Landscape Design Evolution Statement – Site Wide Comparison Table

Tree Planting Strategy – Coordination Review

This document has been prepared to explain the evolution of the approved tree planting proposals and to justify amendments made through the detailed coordination and technical stages.

Northern Linear POS

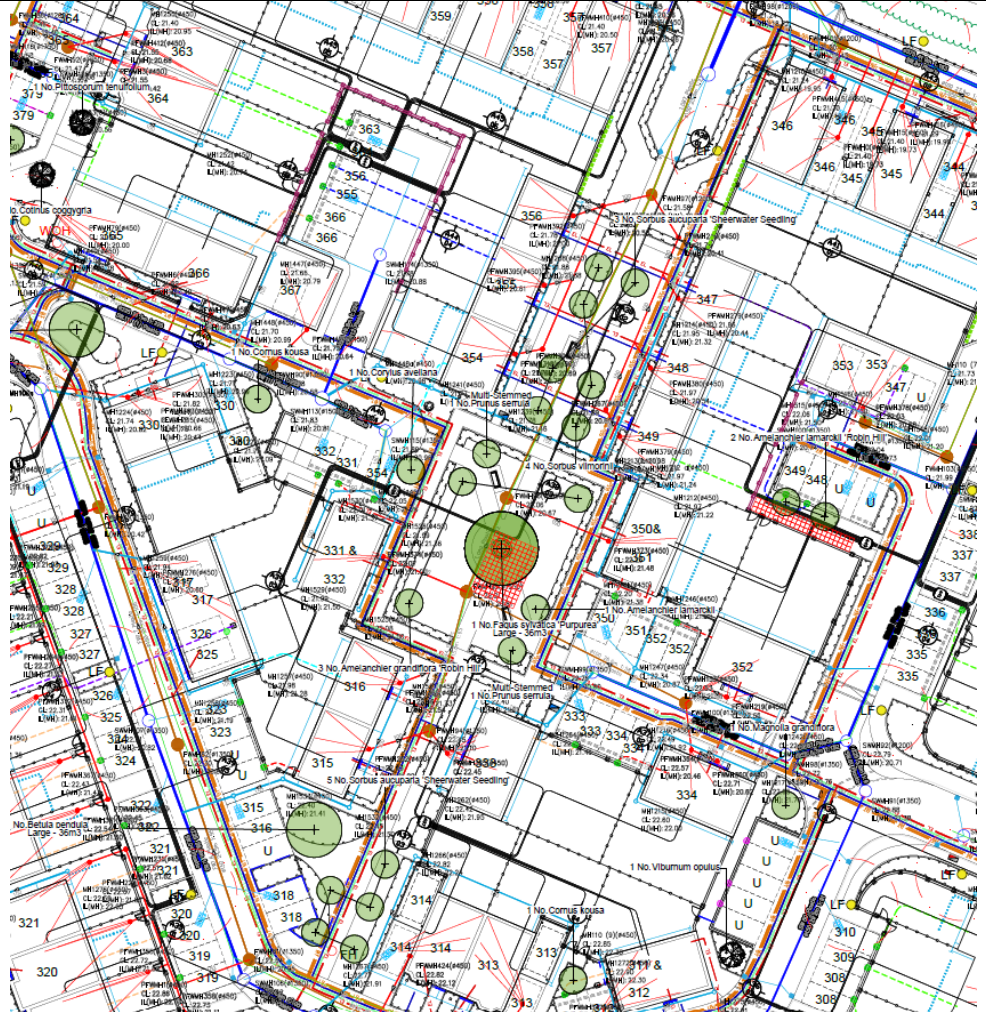
Tree positions were initially adjusted in response to preliminary drainage information and the emerging engineering layout. Tree numbers were subsequently rationalised to reflect a deliverable planting strategy, taking account of underground services, proximity to dwellings, and the need to maintain clear front garden delineation and pedestrian access routes. The layout illustrated two trees adjacent to Plot 357; however, these trees were later omitted following detailed coordination due to their proximity to the dwelling and the limited soil volume available for successful long-term establishment. The introduction of seating areas and public open space features has influenced the final planting arrangement, creating focal points within the landscape and concentrating tree planting into more formal groups and avenues.

As the technical proposals evolved with the other consultants, tree positions within the central square were refined to avoid conflicts with underground infrastructure and service corridors. Additional tree planting opportunities were identified elsewhere within the space to reinforce the landscape structure and maintain the intended character of the approved scheme. These locations have been coordinated with service corridors and are proposed with appropriate root barrier protection where necessary. Overall, the landscape principles established within the approved scheme have been retained. Whilst the final coordinated layout includes a reduction in tree numbers, the overall landscape vision and structural planting framework remain consistent with the original design intent.

Plot 353 and parking nearby

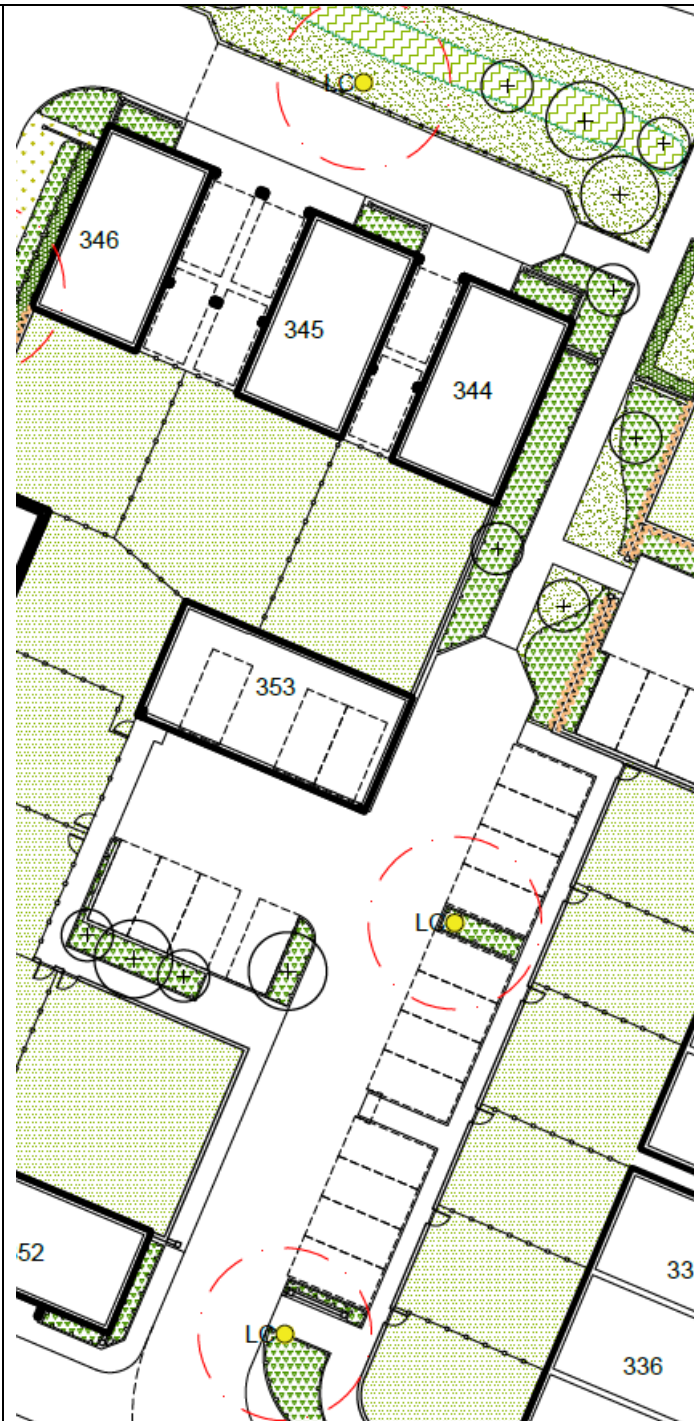
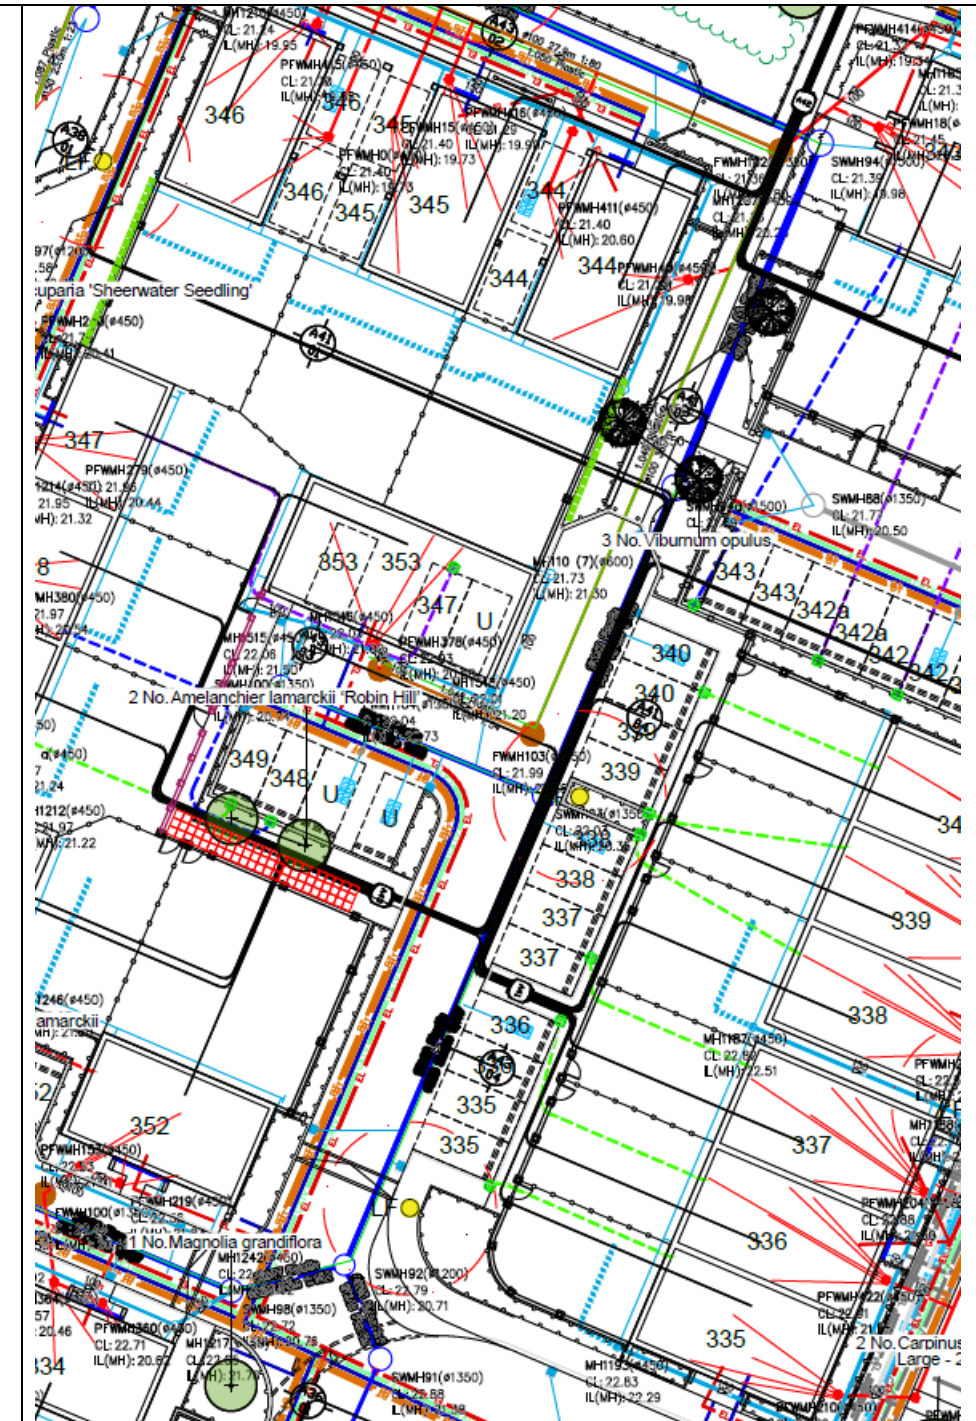
The road layout was revised during the design process, changing from a through-route arrangement to a pedestrian-priority access route. Together with the relocation of Plot 353 and the coordinated lighting layout, these changes resulted in a reduction in the number of achievable tree planting locations.

Trees originally proposed adjacent to the rear garden walls of Plots 343 and 344 were subsequently replaced with feature shrub planting. This amendment was necessary due to limited soil volumes, proximity to foundations, and the rooting constraints associated with the dwelling substructures and proposed services.

The proposed trees located to the front of Plot 353 have been retained and are supported by a root cell system to provide the necessary soil volume for long-term establishment while protecting adjacent infrastructure and accommodating service constraints.

Secondary Road along Plot 317

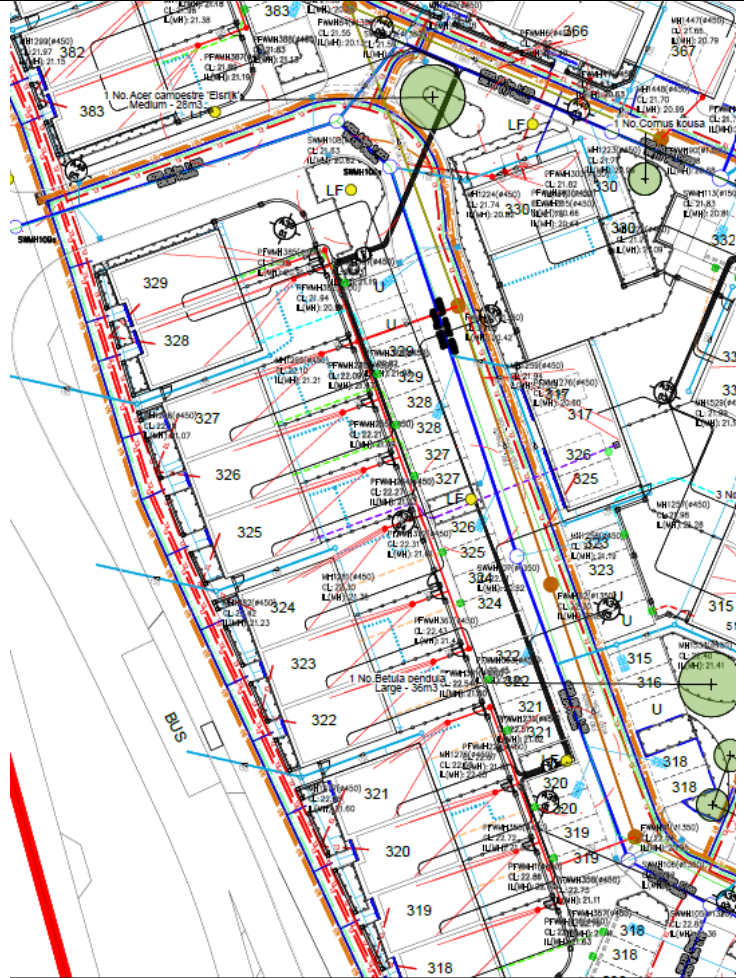
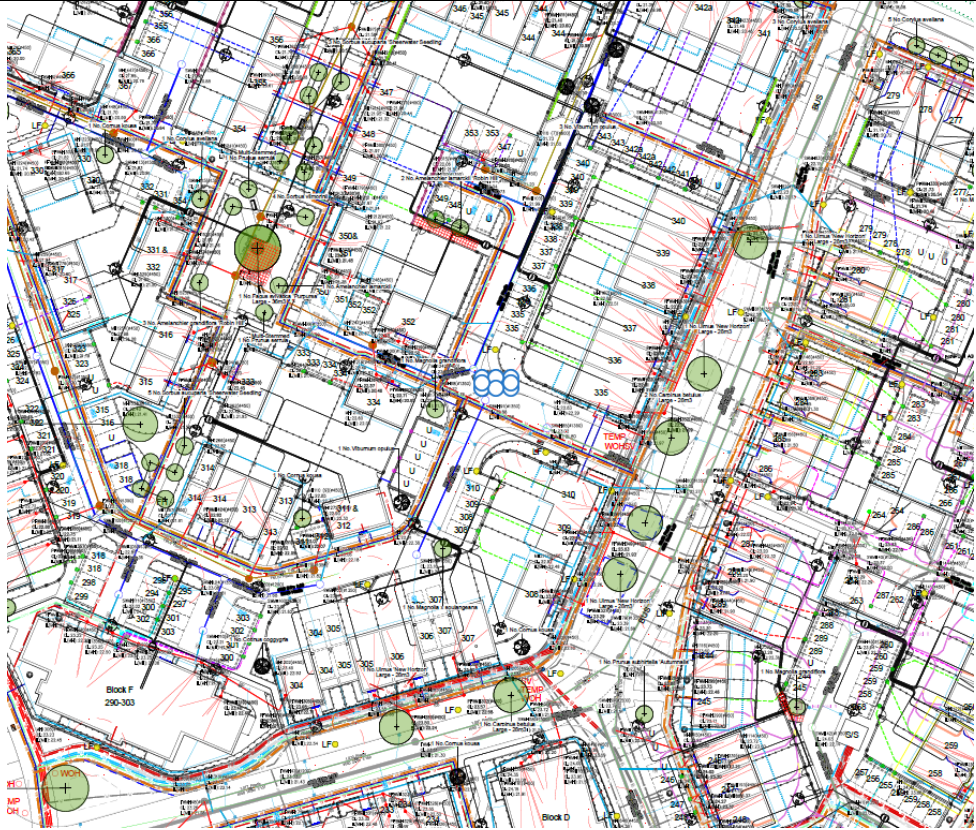
The proposed tree planting was coordinated alongside the lighting layout, bin collection points, pedestrian footpaths serving the parking areas, and the clearance requirements associated with accessible parking bays. These constraints resulted in a reduction in the number of tree planting locations originally illustrated on the Tyler Grange landscape strategy.

As the detailed design progressed, further amendments were made to the parking arrangement opposite Plot 317. The revised parking layout reduced the available planting opportunities within this area and resulted in a further rationalisation of tree numbers. Despite these amendments, the feature tree positioned at the end of the vista in front of Plot 330 continuing to provide a strong focal point and maintain the original landscape design intent.

Block of flats A.1 – A.4

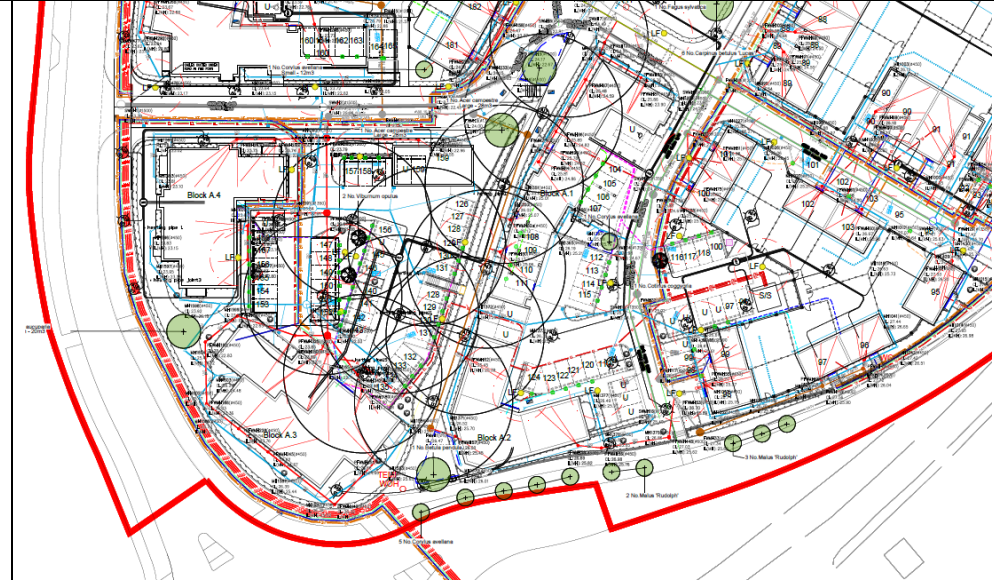
The tree planting proposals broadly follow the landscape vision established within the approved Tyler Grange scheme, with only minor refinements made during the detailed design. Amendments included the omission of trees where proposed locations were too close to residential blocks, where retaining wall for the change of levels along the footpath between the apartment blocks, and where coordination with the lighting layout influenced achievable planting locations.

As the technical design developed, a significant amount of underground infrastructure was introduced within this area, resulting in further coordination requirements. In a number of locations, proposed trees were either omitted or replaced with large feature shrubs where sufficient soil volume and rooting conditions could not be achieved. The principal constraints affecting tree retention were the lighting requirements associated with the parking areas serving Blocks A.3 and A.4, together with the concentration of underground services within adjacent hard landscape areas. Tree planting originally proposed within hard landscaped areas was reviewed and, where necessary, omitted due to the density of underground services and the inability to provide suitable long-term growing conditions. Similarly, the trees proposed adjacent to the boundary to the Phase 3 road frontage was rationalised following coordination with the service corridor running along this boundary.

The Roughets – Tertiary Roads (plots 25-38 / 44-56 / 62-71 / 76-84 / 90-95)

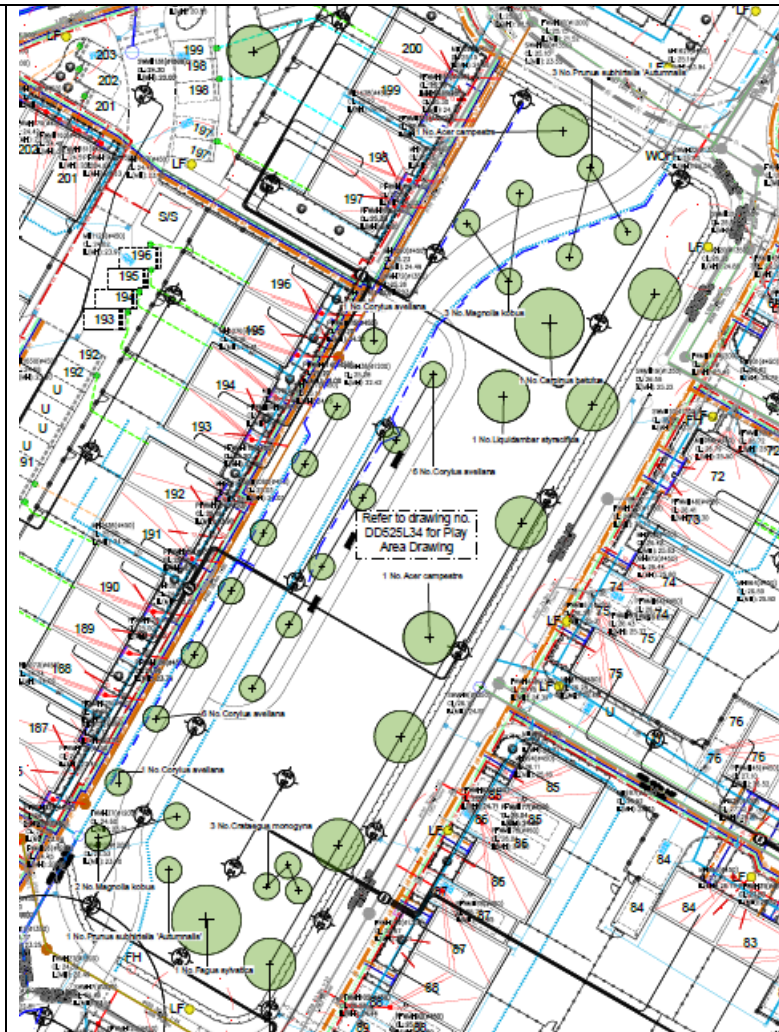
The tree planting proposals broadly follow the landscape vision established within the approved Tyler Grange scheme, with refinements made during the design stage in response to the coordinated lighting and drainage proposals.

As the technical design progressed, proposed tree locations were reviewed against confirmed utility information, soil availability, and construction requirements. In a number of locations, trees were either omitted or replaced with large feature shrubs where sufficient soil volume and long-term growing conditions could not be achieved. Particular constraints arose from the requirement for permeable parking bay construction. Whilst opportunities to utilise root cell systems were considered, the permeable pavement build-up, associated drainage requirements, site soil conditions, and construction constraints limited the ability to increase soil volumes beneath adjacent hard surfaces. As a result, several tree planting locations originally proposed adjacent to the parking areas were not considered technically achievable. Recently the tree planting strategy was subsequently reviewed to identify alternative opportunities for tree provision. This resulted in the reintroduction of trees at the end of the road corridor, supported by root cell systems located beneath the adjacent pedestrian footpath where sufficient soil volumes could be provided without conflicting with the permeable parking bay construction.

A low native hedge has been introduced along parts of the Public Open Space (POS) to assist with visibility requirements, improve spatial definition, and provide a clear and safe interface between the open space and adjacent routes.

Secondary Road From block D-plot 200 to block B including route through plot 209

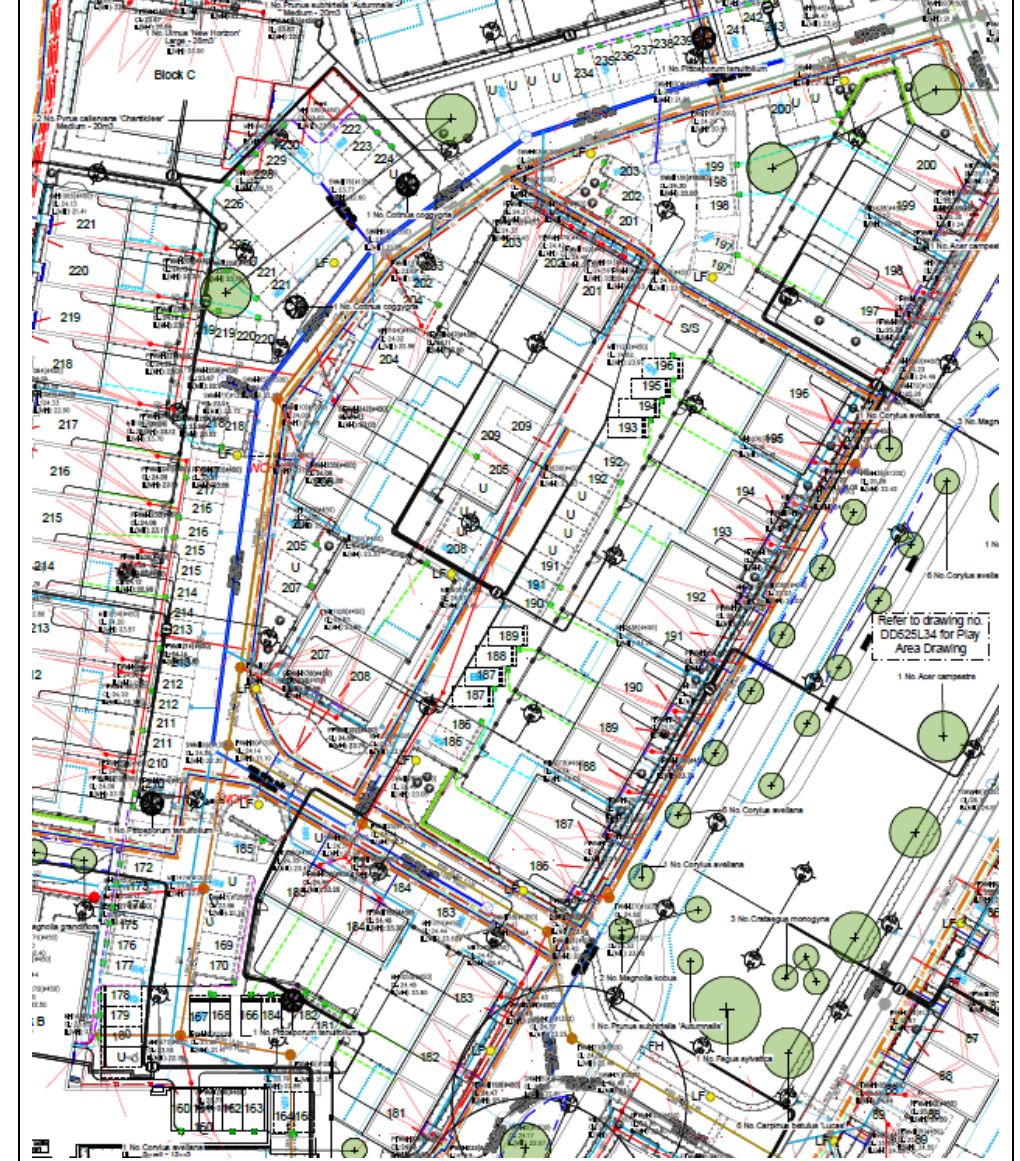
The proposed tree planting was coordinated alongside the lighting layout, bin collection points, pedestrian footpaths serving the parking areas, and the clearance requirements associated with accessible parking bays. These constraints resulted in a reduction in the number of tree planting locations originally illustrated on the Tyler Grange landscape strategy.

As part of the preliminary design process, additional trees were proposed within hard landscape areas adjacent to Block B and along the route through Plot 209 in an effort to maintain the landscape structure and compensate for trees lost through the coordination process. The parking arrangement to the rear of Plots 197–200 was also amended to create larger planting beds and maximise opportunities for tree planting on both sides of the street.

The tree planting proposals were subsequently refined through detailed technical coordination. The trees previously proposed to the front of Plots 207–208 were omitted due to visibility requirements, whilst the row of parking bays to the rear of Plots 210–217 was reconfigured to improve vehicle manoeuvrability.

Further review of the available soil volumes, parking bay construction, and underground infrastructure constraints resulted in the omission of several trees previously proposed within hard landscaped areas (requiring rootcells).

The tree planting strategy was subsequently reviewed to identify alternative opportunities for tree provision and to focus on delivering fewer, but more meaningful, tree planting locations capable of supporting larger, higher-quality specimens with suitable long-term growing conditions.

Tertiary road – Parking area to plots 1-20

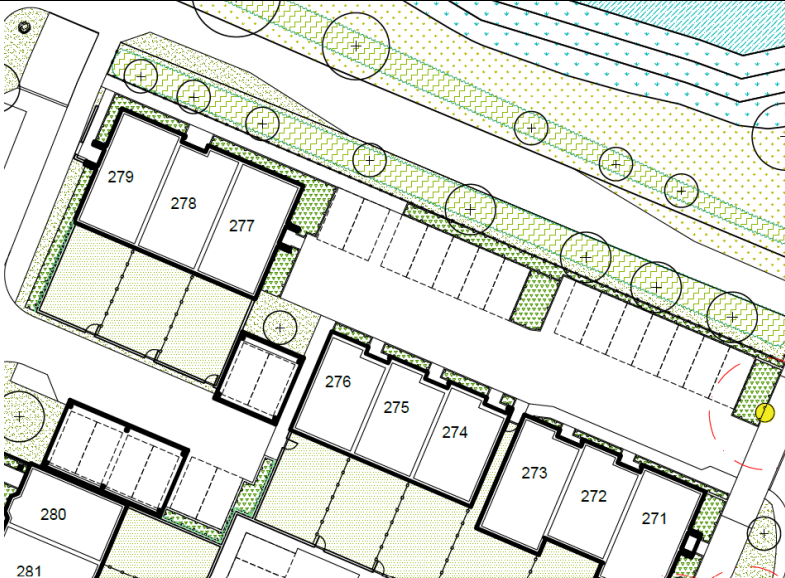
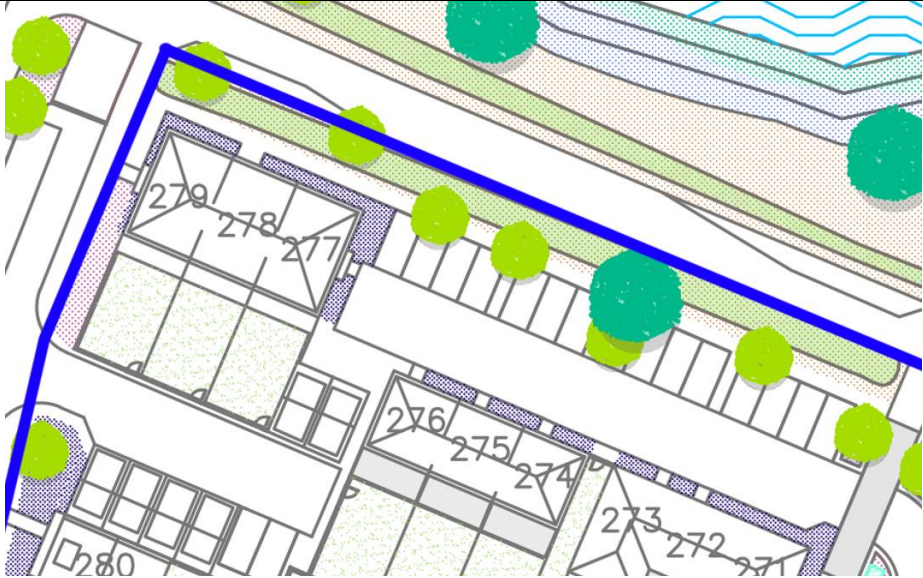
Tree numbers within this area have been rationalised to accommodate car ports, pedestrian footpaths, lighting columns, and underground service requirements associated with the parking arrangement. Changes between plot 2 and 13 allowed tree planting between green strip/pedestrian footpath

Tree planting had to be omitted within this parking area due to proposed services. Lighting columns on planting beds and service runs on the soft area meant omission of tree planting.
